City of Portland, Maine – Building or Use Permit Application 389 Congress Street, 04101, Tel: (207) 874-8703, FAX: 874-8716

COMMUNITY EMPLOYMENT PROJECT 181 BRACKETT STREET PORTLAND, MAINE

RE: 181 Brackett Street, Portland

Re: 181 Brackett Street; 2nd Floor Addition to Garage

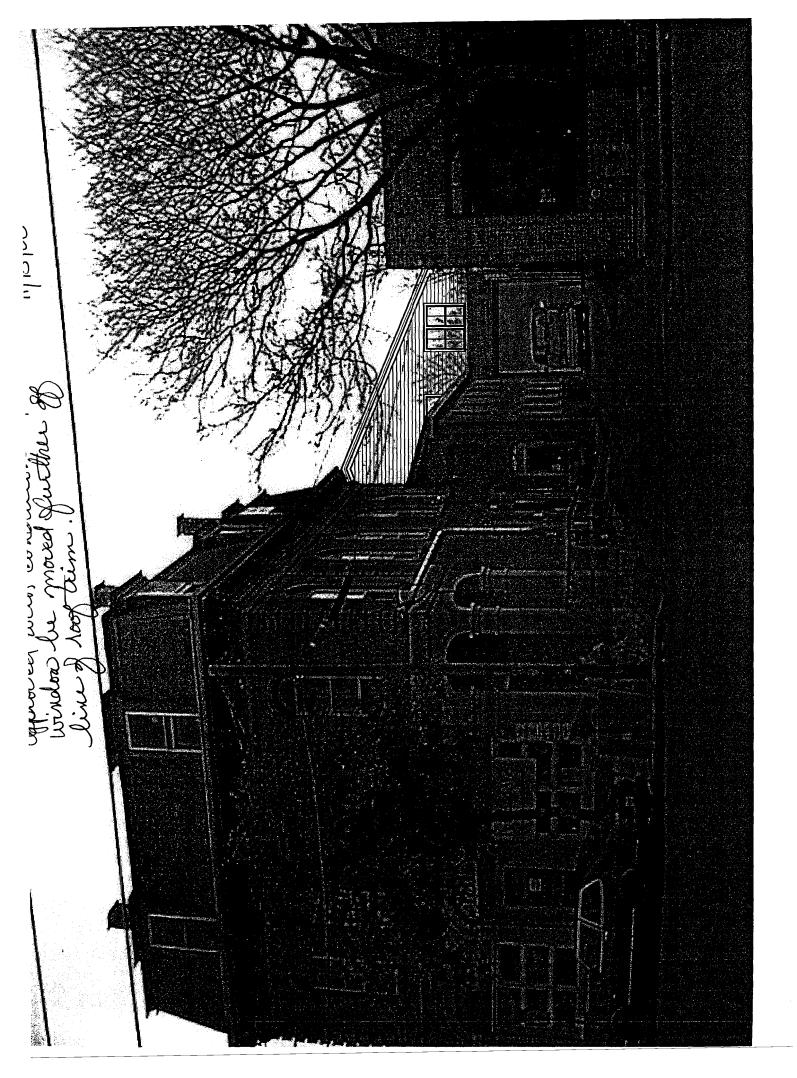
* That the windows on the front facade of the addition be repositioned or scaled back so as not to crowd the rake of the eave.

<u>All improvements shall be carried out as shown on the submitted plans and specifications, except as to comply with the condition above.</u> Changes to the approved plans and specifications and any additional work which may be undertaken must be reviewed and approved by this office prior to construction, alteration, or demolition. If, during the course of completing the approved work, conditions are encountered which prevent completing the approved work, or which require additional or alternative work, you must apply for and receive a Certificate of Appropriateness or Non-Applicability PRIOR to undertaking additional or alternative work.
